Attachment E: Supplemental Information Summary

VERTEX was asked by Beveridge & Diamond to research several other aspects of the Proposed Project. The following provides the results of this additional research:

TRACK ELEVATION EXHIBIT

RETAINING WALL LOCATION EXHIBIT

PROPOSED ALIGNMENT PARCELS
PERMANENT ROW: 0
PERMANENT EASEMENT: 0

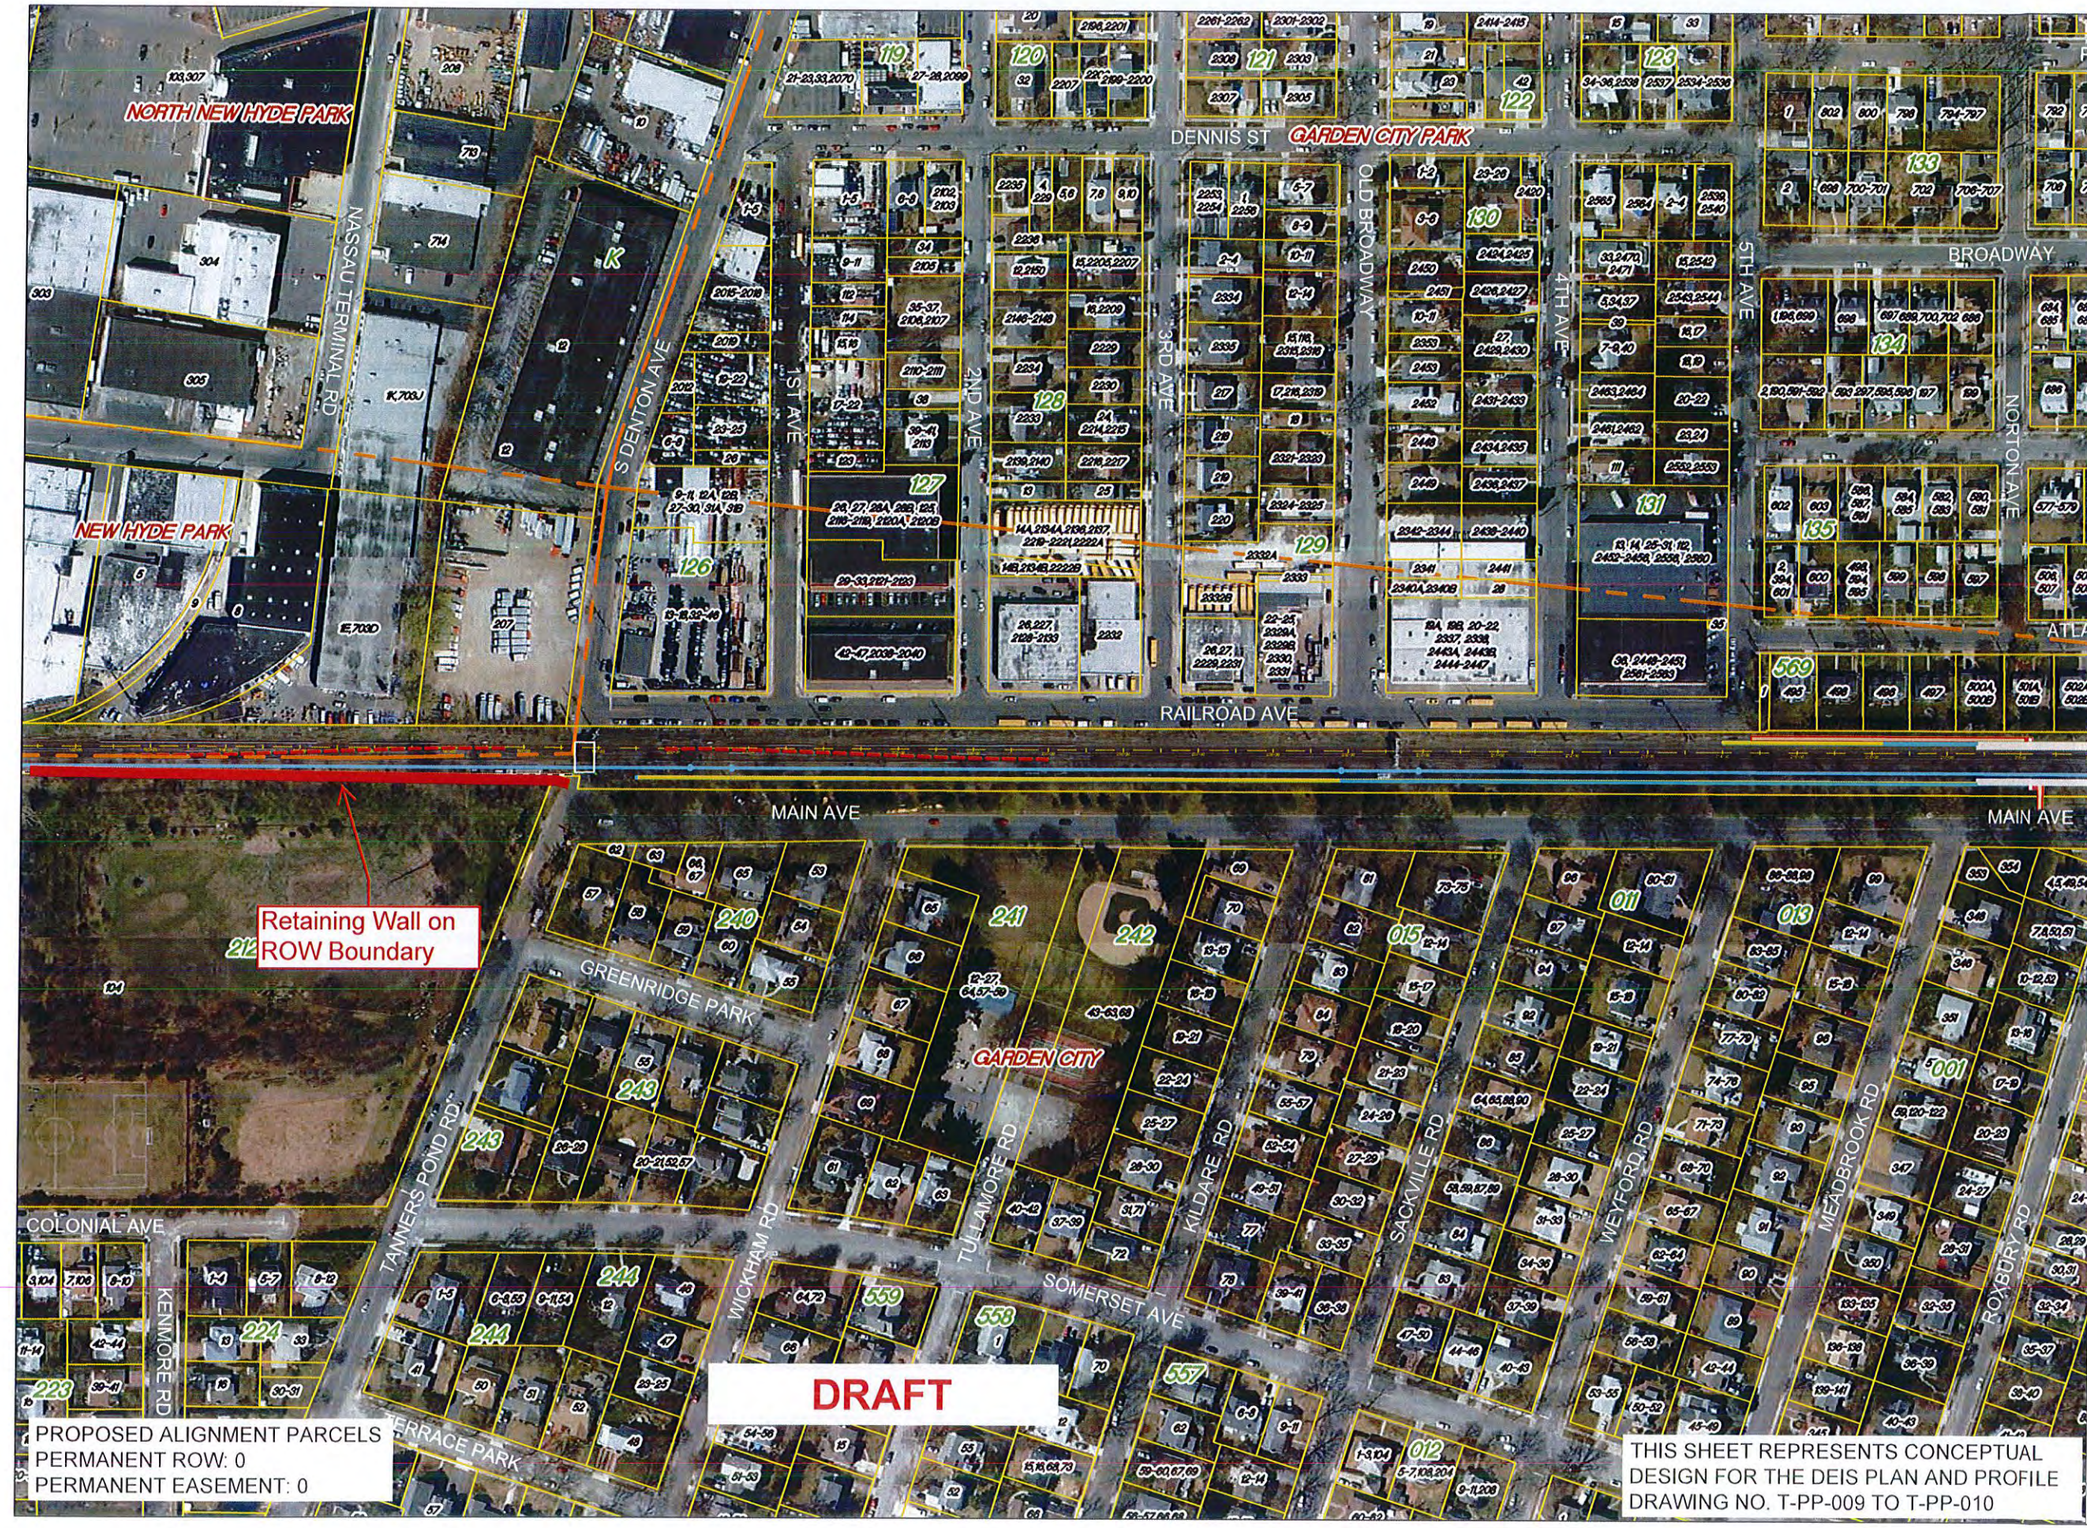
- There are retaining walls proposed nearly continuously on the southern ROW line from Plainfield Avenue to Denton Avenue.
    - There is conflicting information on whether retaining walls will be placed along the northern ROW line

- A graphic representation of the proposed retaining walls is provided in the Exhibit B at the end of this section.
